**TOWN OF NEWBURGH  
PLANNING BOARD  
TECHNICAL REVIEW COMMENTS**

**PROJECT NAME:** FABULOUS EVENTS, INC.  
**PROJECT NO.:** 22-23  
**PROJECT LOCATION:** SECTION 34, BLOCK 2, LOT 25.2, 54, 76, 77  
**REVIEW DATE:** 29 SEPTEMBER 2023  
**MEETING DATE:** 5 OCTOBER 2023  
**PROJECT REPRESENTATIVE:** LANC & TULLY – JOHN QUEENAN, P.E.

Re: Fabulous Events, Inc.  
SBL: 34-2-25.2, 54, 74, 76, 77  
Site Plan – NYS Route 32

# SITE PLAN FOR FABULOUS EVENTS, INC

TREE REMOVAL PLAN FOR

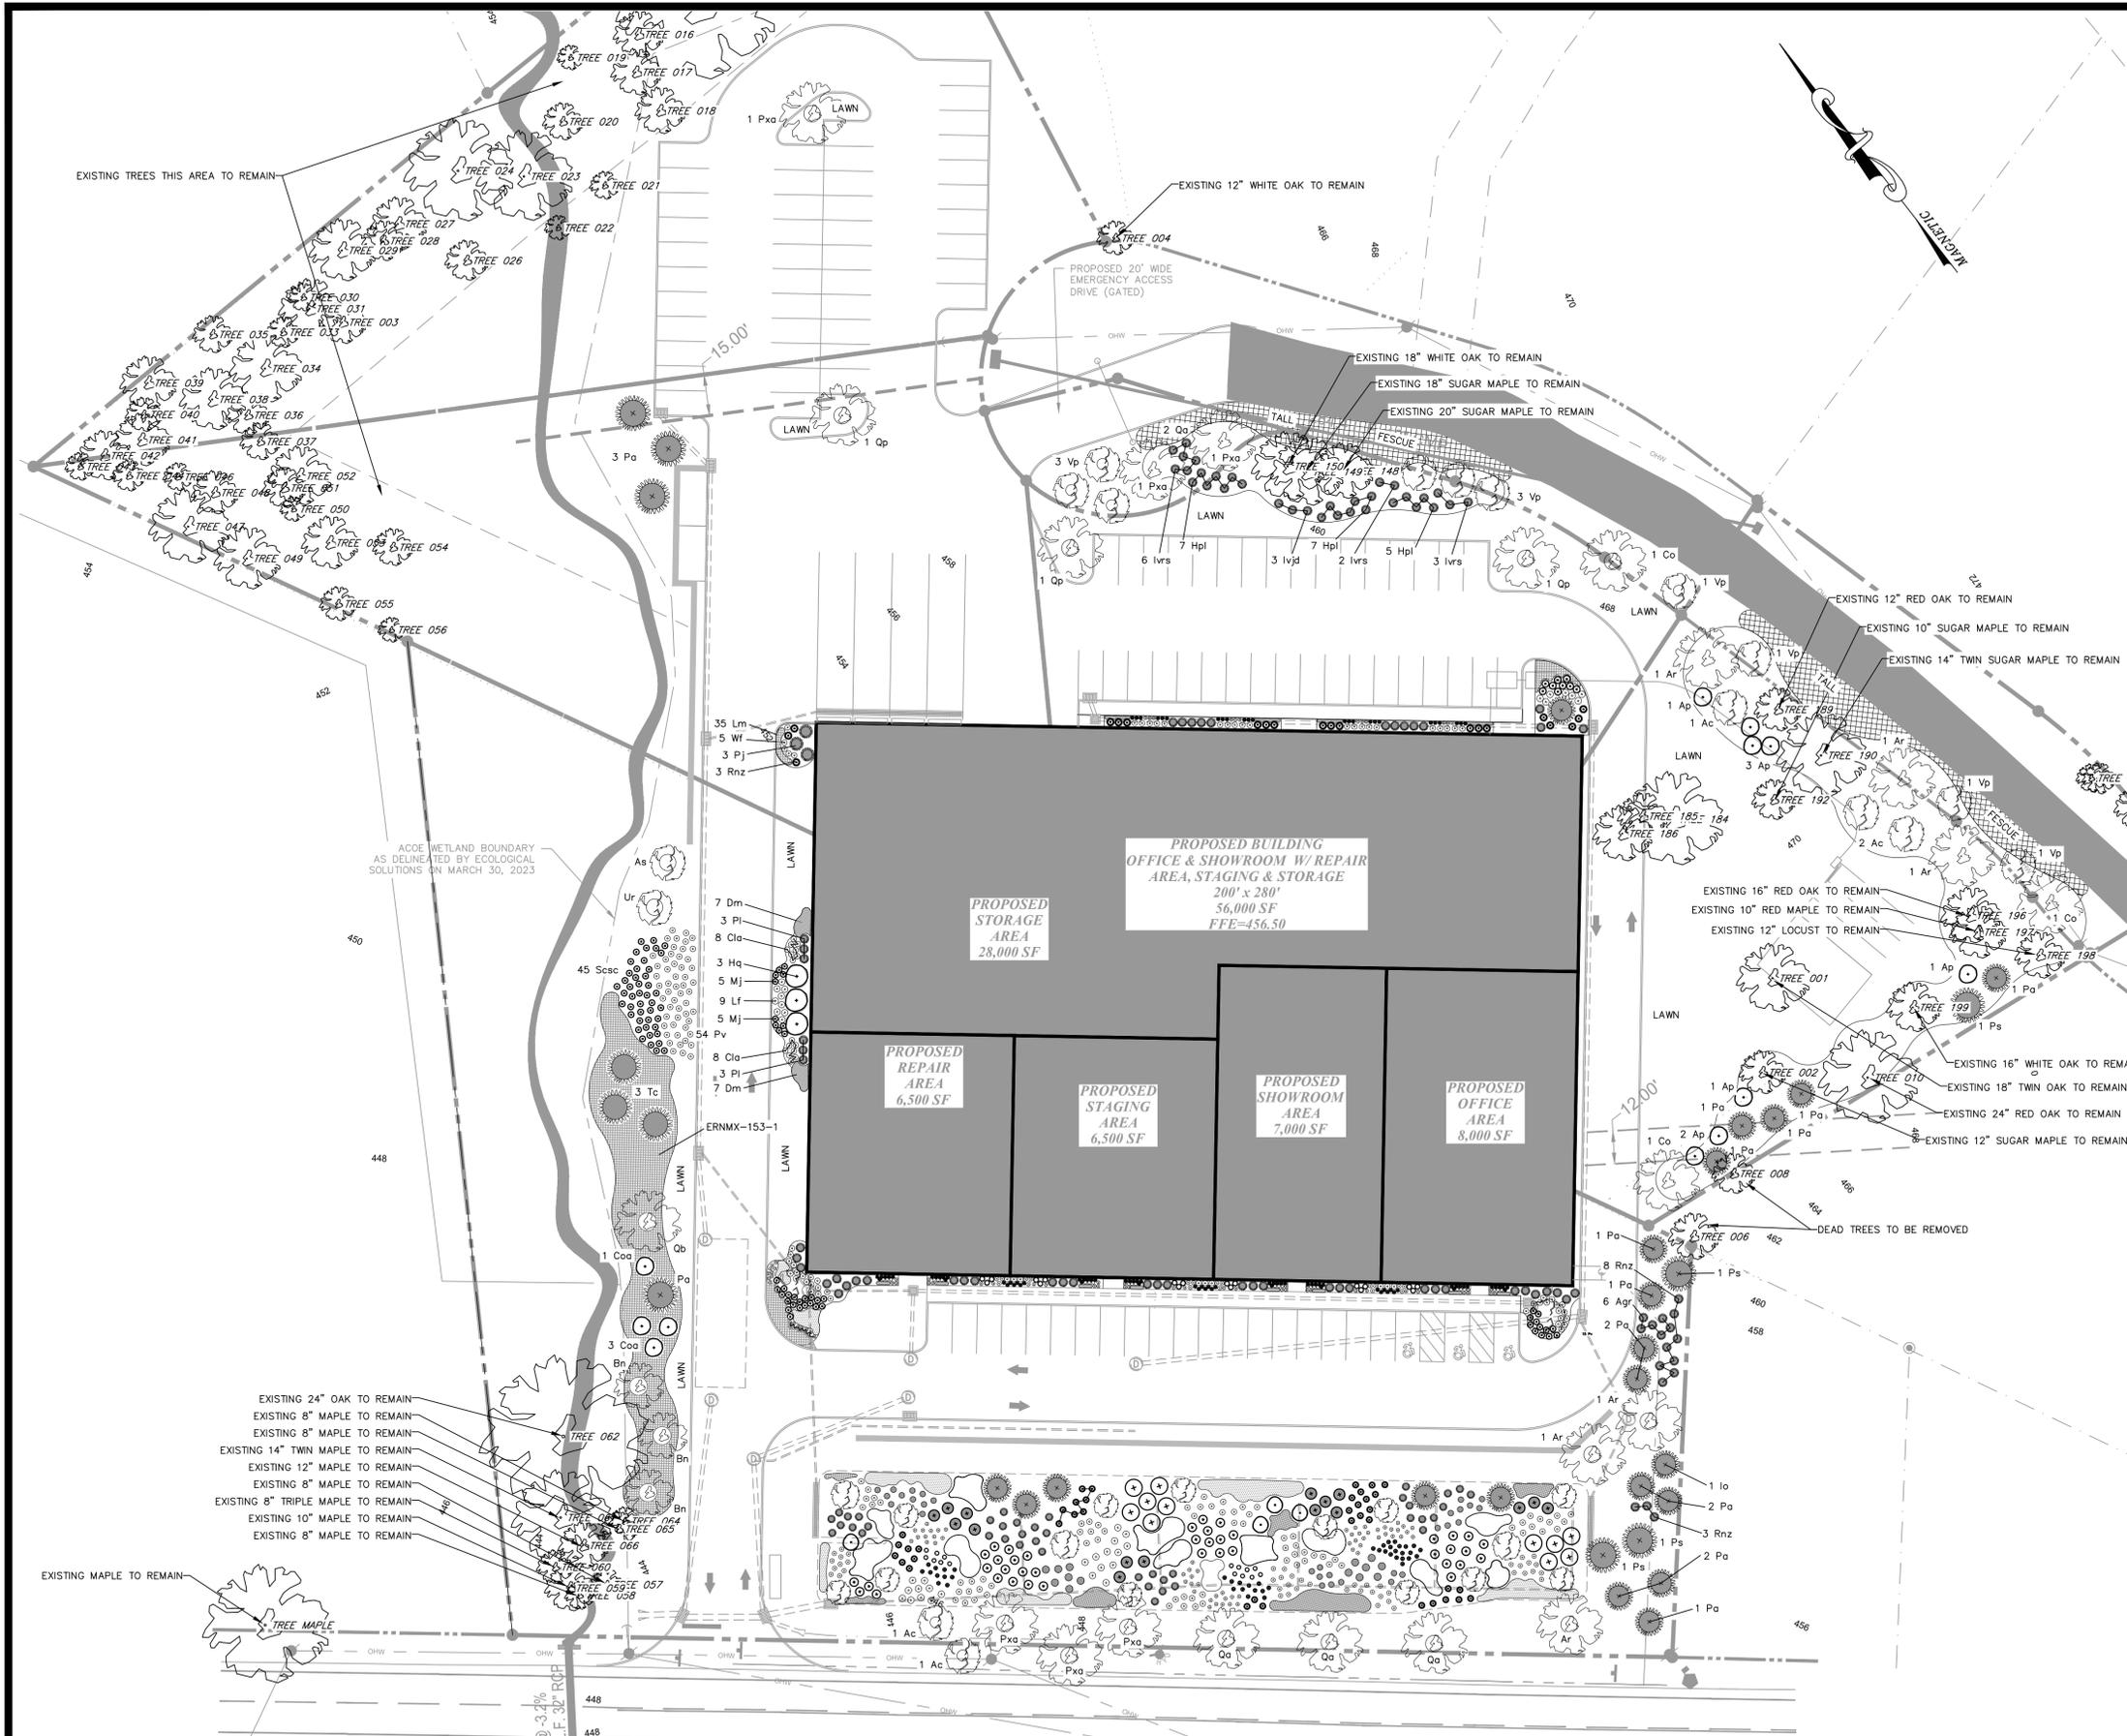
4. Additional information regarding the Tree Protection regulation is required. Comparison of the number of trees removed versus trees to remain must be provided. Calculation for tree planting replacement or fee must be added to the plans.

14. Please note that currently the tree location and removal plan does not list the species of each tree nor the apparent condition of the tree. The list also includes trees with a DBH of 8" or greater. The chart should only show trees with a DBH of 10" or greater. The applicant is in the process of having trees identified and the conditions of the trees assessed. A summary showing total DBH inches of trees on site and total DBH inches of trees to be removed should be shown on the plans.

15. The Tree Removal Plan and Tree Inventory chart are inconsistent. Tree 001 is shown on the plan to remain but is shown in the chart to be removed. Tree 001 can likely be saved as it is located only in the corner of the proposed expansion area. Likewise, the plan shows that Tree 009 should be removed, but the chart says that it will remain. It is likely that this tree will also be able to remain. Please make sure the chart matches the plans to avoid confusion and to make sure the most trees possible can be saved.

**Response: The tree location and removal plan has been updated to provide for the tag number, species and size of all onsite trees over 10" in DBH. The chart has been updated to provide for the total number of trees and the total number to be removed.**

**Response: The tree removal plan has been updated and the total removal figures updated.**

**Response: The tree chart has been revised.**

CU File: LANDSCAPE PLAN.DWG  
Layout: PLAN\_3  
Sheet No.: 13 OF 18

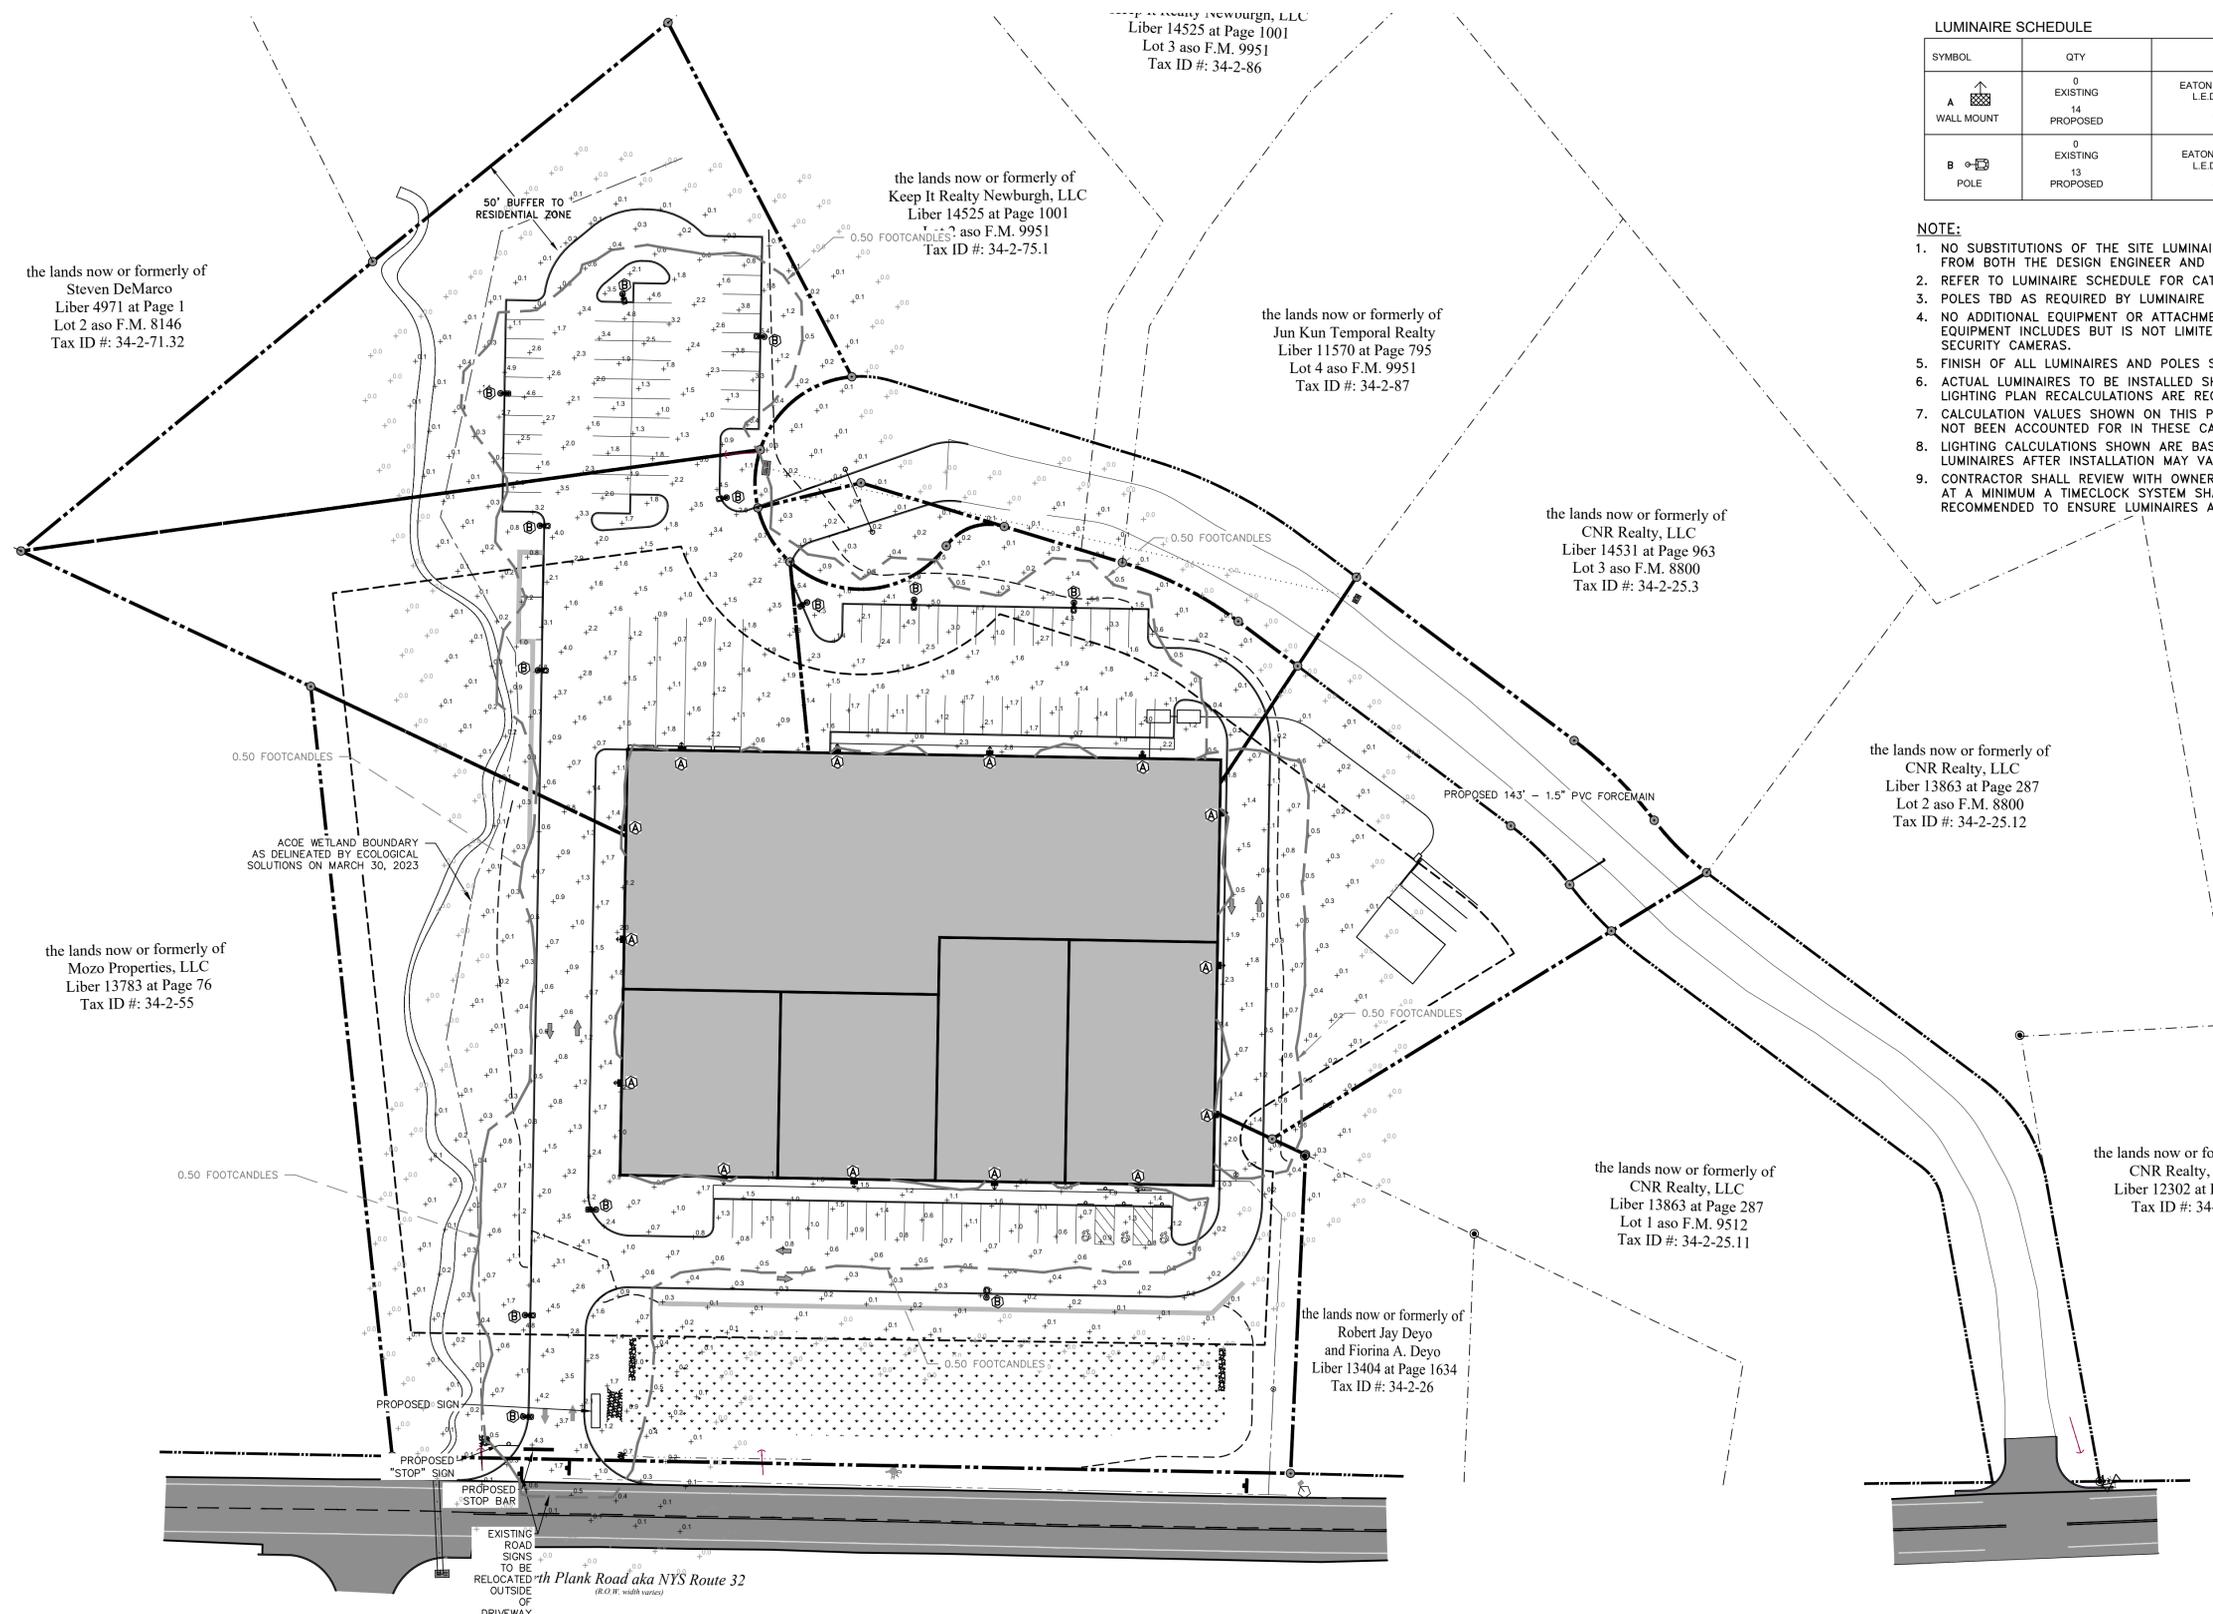
1. Show existing trees to remain on the plan so it is clear how proposed plantings and existing vegetation will form a cohesive landscape that provides screening where necessary.

4. Large empty beds of mulch are proposed around plantings at the east and northeast ends of the site adjacent to Crab Apple Lane. Large mulch beds are unsightly and become very weedy. Reduce the size of planting beds and consider showing tall Fescue below the plantings.

5. To create a naturalistic look that will provide more shade from the south, propose naturalistically placed deciduous trees along the southern angled property line near the septic system. Some 5-6' White Pines can be mixed in just to get some evergreen cover. This will complement other existing trees to remain along the border.

6. Azaleas and Rhododendrons proposed in the planting beds along Crab Apple Lane will suffer as these beds will be very sunny.

7. Propose a groundcover, such as a lawn mix with clover, in the planting islands in the north parking lot to avoid islands consisting entirely of messy, weedy mulch.

9. Plants proposed on the north side of the building will not thrive in sunny areas. Oakleaf Hydrangea may live on that side, but it is too shady for any of the other proposed plants shown except Andromeda, Azalea, and Rhododendron. Please propose species that will tolerate shade such as Clethra, Shadblow Serviceberry, and Bottlebrush Buckeye.

10. The same plants as shown on the west facade of the building are also shown on the east side. The east side of the building will get much less sun, and plant species that like more shade should be proposed there, such as those listed above.

11. White Fir are unacceptable as they are highly sensitive to soil compaction, which often occurs on commercial developments. Blue Spruce are unacceptable as summer humidity fosters the growth of Cyrospora which has been known to decimate Spruces in the area. Oriental Spruce is not acceptable as it is very slow growing and needs to be planted in areas sheltered from winter winds. Acceptable alternative evergreens for the site are Norway Spruce and White Pine.

12. A cultivar must be specified for Winterberry Holly, such as Red Sprite. Additionally, in order for berry production, one male Winterberry Holly must be planted for each 5 females. Jim Dandy is a suitable male Winterberry Holly for the Red Sprite cultivar.

13. The same key (Pa) is used for London Plane Tree and Norway Spruce. Provide a different symbol name for each tree to avoid confusion.

**Response: Existing trees to remain have been shown and labeled on the plan.**

**Response: The beds to the east and northeast have been reduced in size and redesigned. Fescue grass has also been shown to the north of these beds, in the shadiest location.**

**Response: White Pines have been added to this location, per request.**

**Response: Azaleas and rhododendron have been replaced with limelight hydrangea and winterberry holly in these beds.**

**Response: The beds in the northern parking lot have been labeled indicating lawn, to eliminate the concern of messy mulch areas there.**

**Response: Plant beds on north side of building have been redesigned to include more shade tolerant plants including Mahonia, Leucothoe, Clethra and ferns.**

**Response: The plants along the east building façade have been changed to more shade tolerant species including Mahonia, Leucothoe and Clethra.**

**Response: White Fir, Blue Spruce and Oriental Spruce have been removed, in favor of Norway Spruces and Eastern White Pine.**

**Response: Red Sprite cultivar has been indicated on the plant table. The plan has been changed to include Jim Dandy males, and the table also includes those.**

**Response: The key for London Plane Tree has been changed to Pxa.**

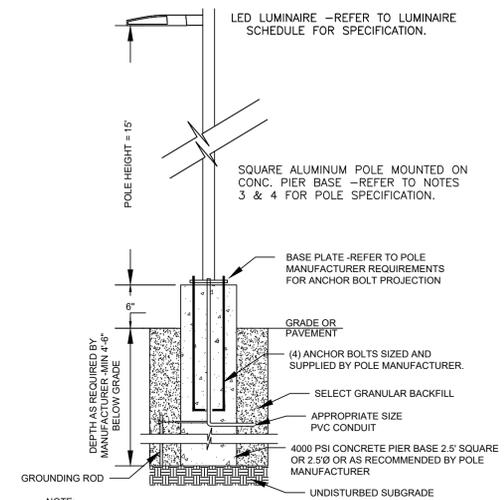
5. The Lighting Plan does not depict site lighting.

**Response: The lighting plan has been updated and is located on Sheet 14.**

**STRIPING DETAILS**  
NOT TO SCALE

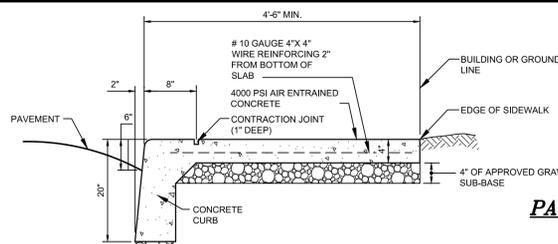
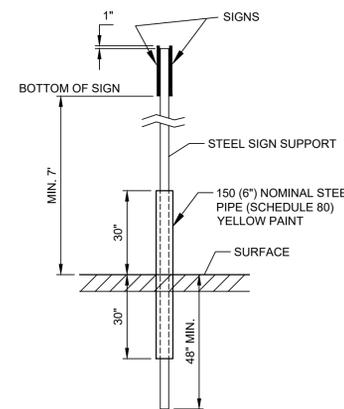
6. Standard parking lot striping for Town of Newburgh should be depicted on the plans. (copy attached)

**Response: The parking lot striping detail on Sheet 16 has been updated.**
